LRN-03-0148  
LCR S03-02

**REQUEST FOR CHANGES TO TECHNICAL SPECIFICATIONS  
TABLE 3.3-1, REACTOR TRIP SYSTEM INSTRUMENTATION  
SALEM NUCLEAR GENERATING STATION, UNITS 1 AND 2  
FACILITY OPERATING LICENSES DPR-70 AND DPR-75  
DOCKET NOS. 50-272 AND 50-311**

**EVALUATION OF REVISIONS TO THE TECHNICAL SPECIFICATIONS  
TABLE 3.3-1, "REACTOR TRIP SYSTEM INSTRUMENTATION"  
CHANGE THE "CONDITION AND SETPOINT" DESCRIPTION  
FOR THE P-7 PERMISSIVE TO REFLECT RELOCATION  
OF TURBINE PRESSURE TRANSMITTERS**

Figure 1  
Current Location of Transmitters PT505/506

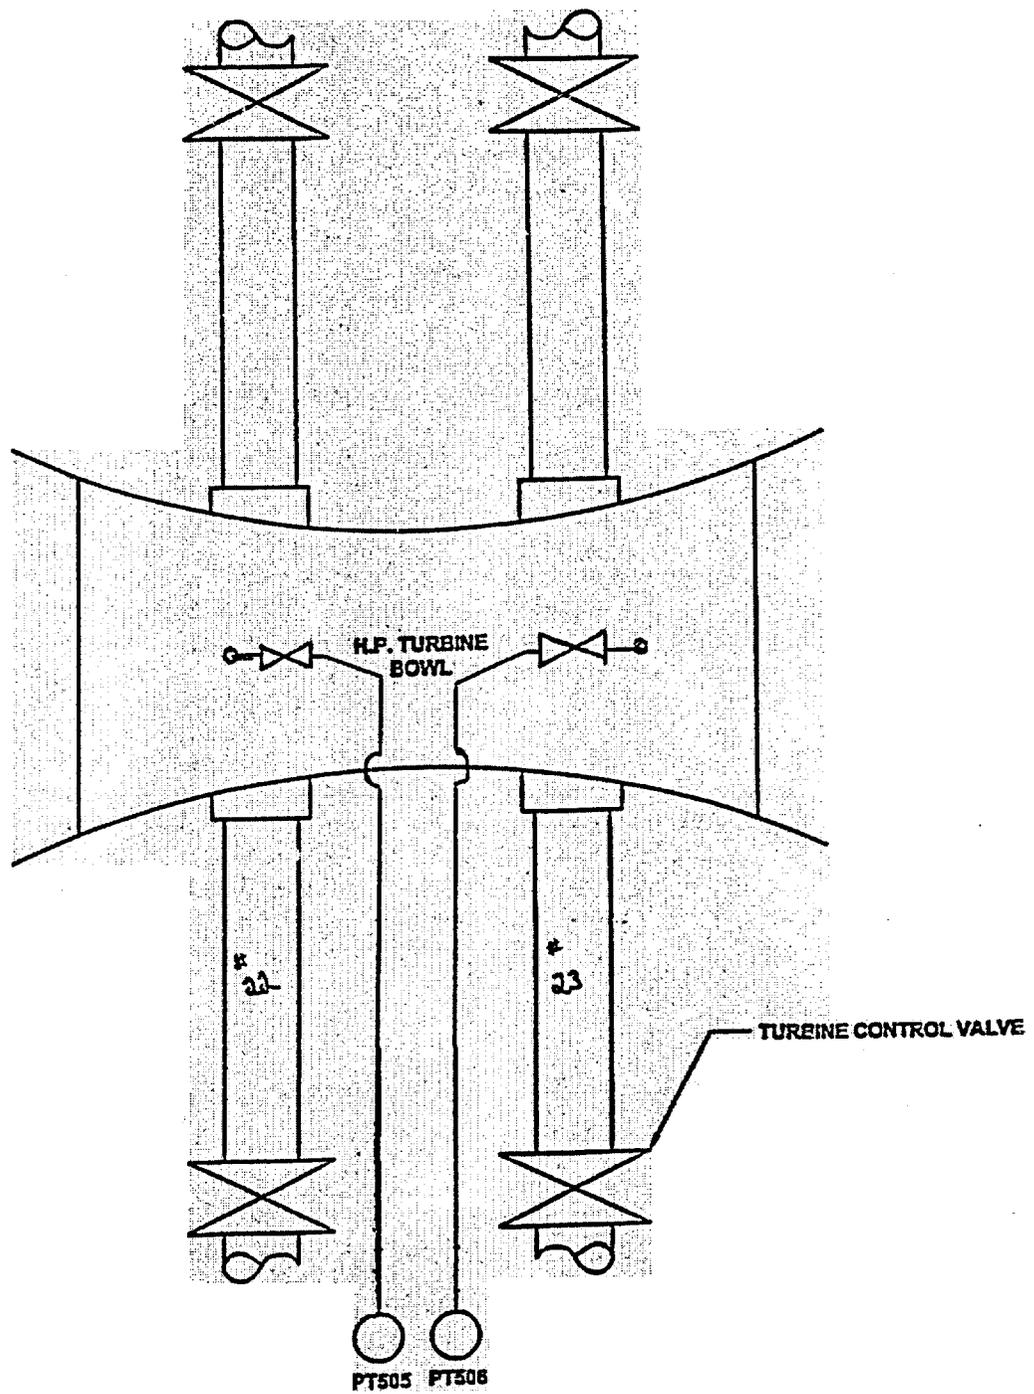
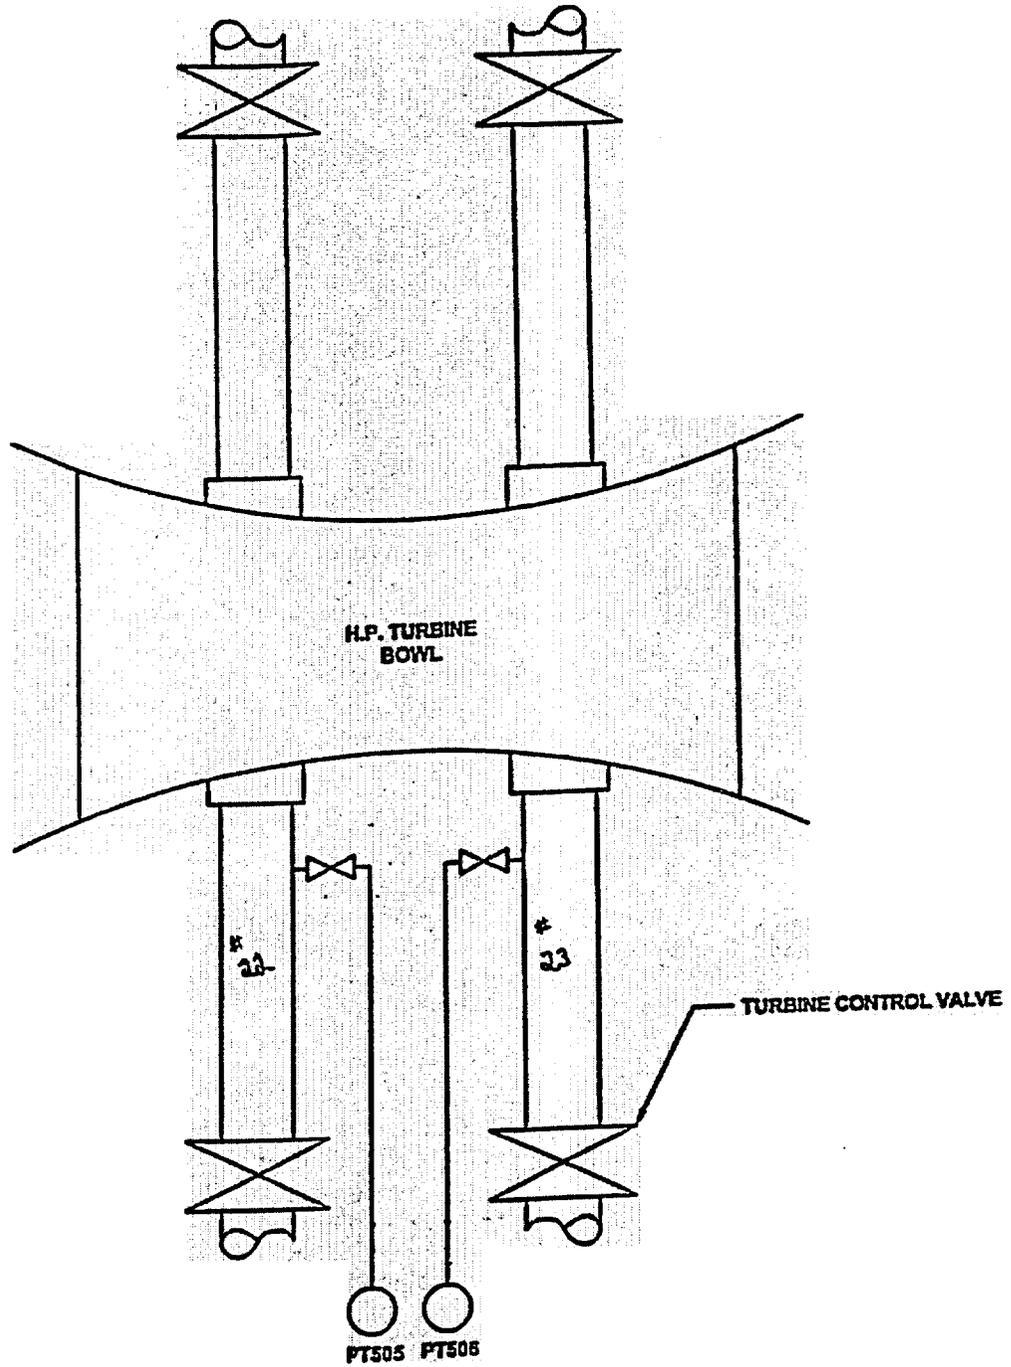
The current turbine configuration has two pressure taps on the first stage of the turbine downstream of the control stage (one at the turbine end and one at the generator end) to measure the impulse pressure. As part of the turbine upgrade/electrical power uprate program, the rotor and stationary blades of the High Pressure Turbine (HPT) are being replaced. To support this effort, the pressure taps are being relocated immediately upstream of the turbine on the turbine steam inlets.

Since the pressure downstream of the reaction blades is non-linear, the turbine redesign moves the pressure sensing taps for pressure transmitters PT505/506 to just upstream of the inlet steam emission ring, but downstream of the turbine governor valve.

The current PT505/506 locations are shown in Figure 1. The new locations for the transmitters are shown in Figure 2.

**Figure 2**  
**Relocated Pressure Transmitters PT505/506**
